**Customer / Dealer Advisory**

**Subject: M2 All-Wheel Drive Passenger Side Step Modification.**

Models Affected: Specific Freightliner M2 106 manufactured January 27, 2017, through August 8, 2018 and equipped with an all-wheel drive chassis.

Fig. 1

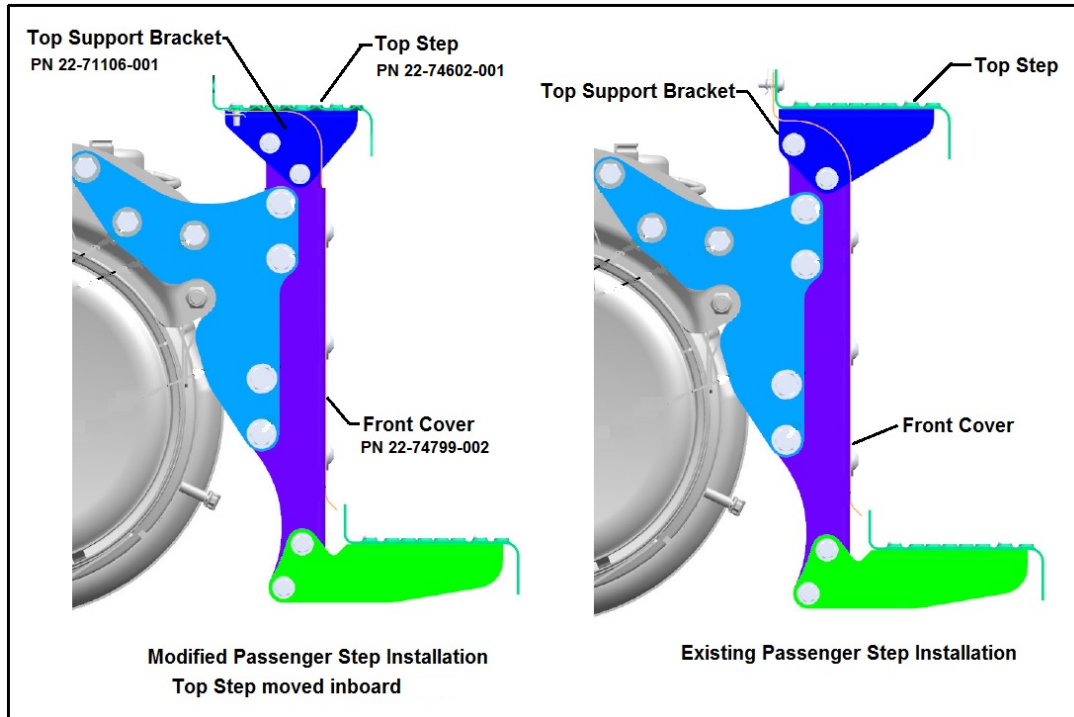
**The passenger side top step will be relocated inboard to increase the horizontal spacing related to the bottom step, the top step will be moved inboard approximately 3.34”.**

1. Park the vehicle on a level surface, shut down the engine, and set the parking brake. Chock the rear tires.
2. Remove the existing passenger side top step. Save the fasteners for reuse. Fig. 1.
3. Remove front cover. Save the fasteners for reuse.
4. Remove the existing passenger side top support brackets. Save the fasteners for reuse.
5. Install the replacement top support brackets P/N 22-71106-001. Fig.1.
  - 5.1 Tighten the 3/8” fasteners to 26 ft lbs.
6. Install the replacement front cover P/N 22-74799-002.
  - 6.1 Tighten the 5/16” fasteners to 11 ft lbs.
- 7 Install the replacement top step P/N 22-74602-001
  - 76.1 Tighten the 1/4” fasteners to 5 ft lbs.
